## **Fosse Green Energy Development Consent Order – Additional Submissions**

### **Planning Inspectorate Case Reference: EN010154**

## Appendix 1 – Response to NatPower Submissions

## Appendix 2 – Indicative Layout

NatPower BESS and Export Cable Route

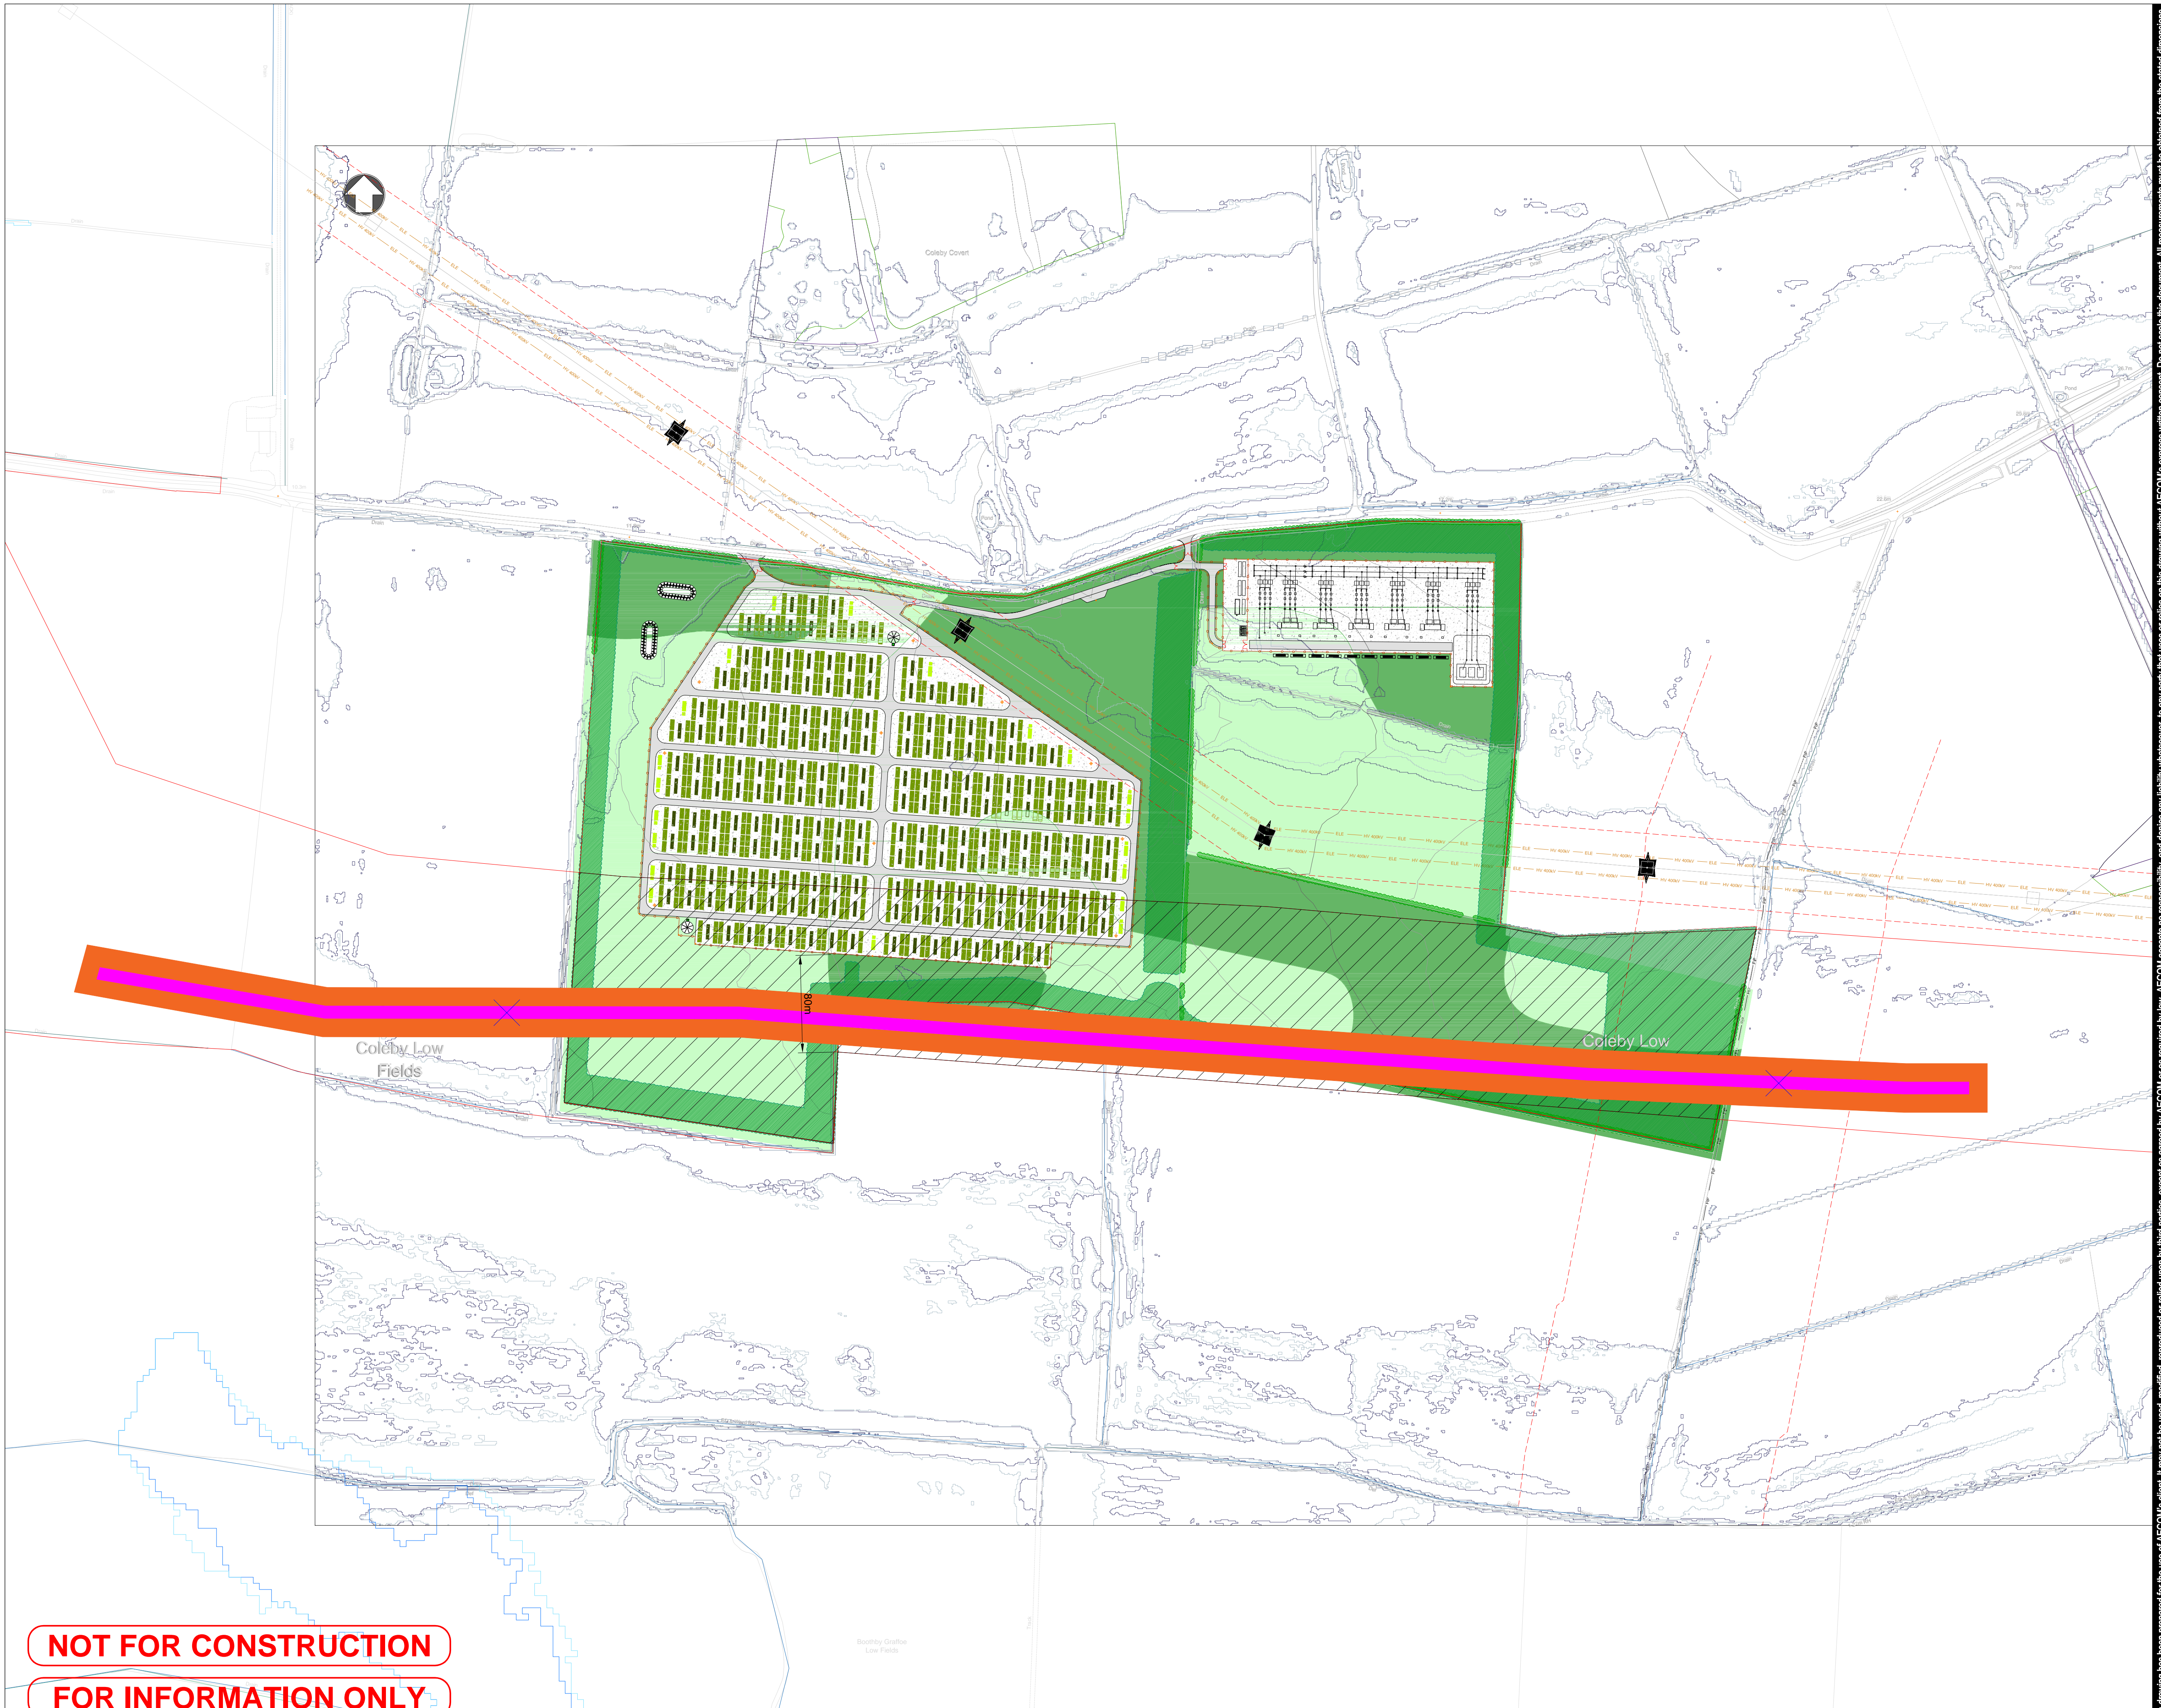
<p><b>Operational Compatibility and Access Concerns</b> The Application provides inadequate clarity regarding how the Applicant intends to secure access for inspection, maintenance, or fault repair along the section of cable proposed within the Site.</p> <p>Emergency repair works would typically require unrestricted temporary working areas, excavation, heavy plant, and reliable operational access. It is unclear how this could be delivered without substantial disruption to, or the temporary suspension of, the BESS Project’s construction or operation.</p>	<p>It is not unusual for underground cable routes to co-exist with other development. Whilst it is correct that there should be no built development over the cable once installed, the operational area affected would be relatively limited (i.e. an easement of 10m in width for the 60-year operational lifetime) and this protected corridor could be integrated into the landscaping scheme and layout of the proposed Brant BESS in order to minimise any impact on operational efficiencies.</p> <p>Once installed and operational, it is unlikely that the cable itself would require unplanned maintenance within the operational period. If emergency repair works were required, this would be accommodated within the easement strip of 10m, so would have no detrimental effect on the wider operational site of the proposed Brant BESS. Access and working areas would not be required outside of the 10m easement strip.</p>

<b>NatPower UK Submission</b>	<b>Applicant Response</b>
<p>This uncertainty creates material operational risk for both projects and highlights the inherent incompatibility of locating a strategic transmission cable through land required for energy storage infrastructure. The absence of a credible operational access strategy weighs strongly against the appropriateness of the proposed alignment.</p> <p>Further, the presence of a high voltage cable and associated easements within the BESS Project's red line boundary would effectively sterilise the Site, limiting the positioning of battery units, transformers, access routes, laydown areas, and other operational infrastructure. Co-locating a transmission-grade cable corridor and a BESS installation within the same development parcel is not practically or safely achievable.</p>	<p>The design provided by NatPower in its objection shows the Brant BESS compound would be approximately 450m in length. If planning permission for the proposed Brant BESS is granted, at the detailed design stage post-consent, the cable route for the Proposed Development can be designed so that there is a jointing bay either side of the Brant BESS facility, which would be accessed under the easement over the land. This approach would allow the cable to be pulled out and replaced if required without any interference on the proposed Brant BESS, i.e. it negates the need for maintenance crews associated with the Proposed Development to access the Brant BESS site and disrupt the day-to-day activities within the BESS. Alternatively, if the Proposed Development cable circuit is installed in land south of the proposed Brant BESS compound, it would be outside of the operational compound of the proposed Brant BESS. Maintenance vehicles would be able to access the cable from the public highway at Hill Rise and enter the fields west of where the proposed Brant BESS site overlaps the Order Limits, either from a point near Broughton Lane (within the Order Limits) or, with landowner agreement, from a closer point along Hill Rise using the existing farm access into the field where the cable circuit will be laid. The approach to the design in this location would be subject to the detailed design process, which would be undertaken should consent for the Proposed Development be granted.</p> <p>Whilst the precise location of the easement strip has not yet been confirmed, flexibility is necessary to enable engagement with NatPower on the most appropriate location within the Order Limits for the routing of the cable in order to minimise impact on the proposed Brant BESS whilst allowing the Proposed Development to come forward. This will ensure that the site of the proposed Brant BESS would not be sterilised and that equipment and apparatus for the BESS can be positioned without any limitations. For the reasons set out above, the Applicant is not aware of any safety reasons why the two projects cannot be brought forward together.</p> <p>A drawing is included at Appendix 2 showing the latest proposed Brant BESS layout, submitted to the Examination by NatPower as part of its Deadline 3 Submission [REP3-070], overlaid with one scenario for the working corridor for the installation of the Proposed Development 400kV buried cable circuit and operational easement. The installation will require an approximately 30-40m wide working area for the trenching, laydown, spoil, and vehicle movements, after which an easement</p>

<p>The presence of a high-voltage cable and associated easements within the BESS red line would result in the effective sterilisation of the land, preventing any surface structures within a cable exclusion area, preventing the implementation and operation of the LDES project.</p> <p>In particular, the exclusion zone would prevent the siting of battery units, transformers, access routes, construction areas, and operational infrastructure, while introducing unacceptable safety, construction, and operational constraints. In practical terms, the coexistence of a third-party electricity cable cutting through our BESS facility area would be incompatible.</p>	<p>It is not unusual for underground cable routes to co-exist with other development. Whilst it is correct that there should be no built development over the cable once installed, the operational area affected would be relatively limited (i.e. an easement of 10m in width for the 60-year operational lifetime) and this protected corridor could be integrated into the landscaping scheme and layout of the proposed Brant BESS in order to minimise any impact on operational efficiencies.</p> <p>Once installed and operational, it is unlikely that the cable itself would require unplanned maintenance within the operational period. If emergency repair works were required, this would be accommodated within the easement strip of 10m, so would have no detrimental effect on the wider operational site of the proposed Brant BESS. Access and working areas would not be required outside of the 10m easement strip.</p> <p>The design provided by NatPower in its objection shows the Brant BESS compound would be approximately 450m in length. If planning permission for the proposed Brant BESS is granted, at</p>

<b>NatPower UK Submission</b>	<b>Applicant Response</b>
<p>I am also concerned that the DCO application provides insufficient clarity as to how the Applicant would access the cable for inspection, maintenance, or fault repair where it passes through or adjacent to the LDES site.</p> <p>In the event of a cable fault, emergency repair works would likely require unrestricted access, excavation, plant movements, and large working areas. It is unclear how such access could be safely or practically achieved without significant disruption to, or temporary shutdown of, the LDES facility.</p> <p>This uncertainty gives rise to delivery and operational risk. It also reinforces the incompatibility of locating a 400kV transmission cable within land intended for large-scale strategic LDES infrastructure (this LDES project being 1GW/8GWh), particularly where long-term operational resilience and availability for the transmission network are critical. The lack of a clear, workable access strategy further weighs against the appropriateness of the proposed DCO.</p>	<p>the detailed design stage post-consent, the cable route for the Proposed Development can be designed so that there is a jointing bay either side of the Brant BESS facility, which would be accessed under the easement over the land. This approach would allow the cable to be pulled out and replaced if required without any interference on the proposed Brant BESS, i.e. it negates the need for maintenance crews associated with the Proposed Development to access the Brant BESS site and disrupt the day-to-day activities within the BESS. Alternatively, if the Proposed Development cable circuit is installed in land south of the proposed Brant BESS compound, it would be outside of the operational compound of the proposed Brant BESS. Maintenance vehicles would be able to access the cable from the public highway at Hill Rise and enter the fields west of where the proposed Brant BESS site overlaps the Order Limits, either from a point near Broughton Lane (within the Order Limits) or, with landowner agreement from a closer point along Hill Rise using the existing farm access into the field where the cable circuit will be laid. The approach to the design in this location would be subject to the detailed design process, which would be undertaken should consent for the Proposed Development be granted.</p> <p>Whilst the precise location of the easement strip has not yet been confirmed, flexibility is necessary to enable engagement with NatPower on the most appropriate location within the Order Limits for the routing of the cable in order to minimise impact on the proposed Brant BESS whilst allowing the Proposed Development to come forward. This will ensure that the site of the proposed Brant BESS would not be sterilised and that equipment and apparatus for the BESS can be positioned without any limitations. For the reasons set out above, the Applicant is not aware of any safety reasons why the two projects cannot be brought forward together.</p> <p>A drawing is included at Appendix 2 showing the latest proposed Brant BESS layout, submitted to the Examination by NatPower as part of its Deadline 3 Submission [REP3-070], overlaid with one scenario for the working corridor for the installation of the Proposed Development 400kV buried cable circuit and operational easement. The installation will require an approximately 30-40m wide working area for the trenching, laydown, spoil, and vehicle movements, after which an easement width of 10m will be required during operation above which hard infrastructure would need to be avoided but shallow root landscaping can be included. The drawing shows there is approximately</p>

NatPower UK Submission	Applicant Response
	<p>width of 10m will be required during operation above which hard infrastructure would need to be avoided but shallow root landscaping can be included. The drawing shows there is approximately an 80m wide corridor between the most southerly part of the proposed Brant BESS compound and the southerly extent of the Order Limits, within which the 30-40m wide working corridor and 10m easement can be located. The drawing also shows how the jointing bays could be located outside of the Brant BESS facility to avoid any interaction during the operation of the Proposed Development.</p> <p>As noted above, the Applicant remains committed to working in co-operation with NatPower to ensure the agreed detailed design and operational interfaces between the projects are appropriately managed, so that the projects can co-exist. Following internal technical review, the Applicant is not aware of any reason why the two projects cannot be brought forward together and considers there is sufficient flexibility within the application boundary for the proposed Brant BESS and the Order Limits of the Proposed Development to achieve this, as demonstrated by the drawing attached at Appendix 2.</p>

NatPower UK Submission	Applicant Response
	<p>an 80m wide corridor between the most southerly part of the proposed Brant BESS compound and the southerly extent of the Order Limits, within which the 30-40m wide working corridor and 10m easement can be located. The drawing also shows how the jointing bays could be located outside of the Brant BESS facility to avoid any interaction during the operation of the Proposed Development.</p> <p>As noted above, the Applicant remains committed to working in co-operation with NatPower to ensure the agreed detailed design and operational interfaces between the projects are appropriately managed, so that the projects can co-exist. Following internal technical review, the Applicant is not aware of any reason why the two projects cannot be brought forward together and considers there is sufficient flexibility within the application boundary for the proposed Brant BESS and the Order Limits of the Proposed Development to achieve this, as demonstrated by the drawing attached at Appendix 2.</p>
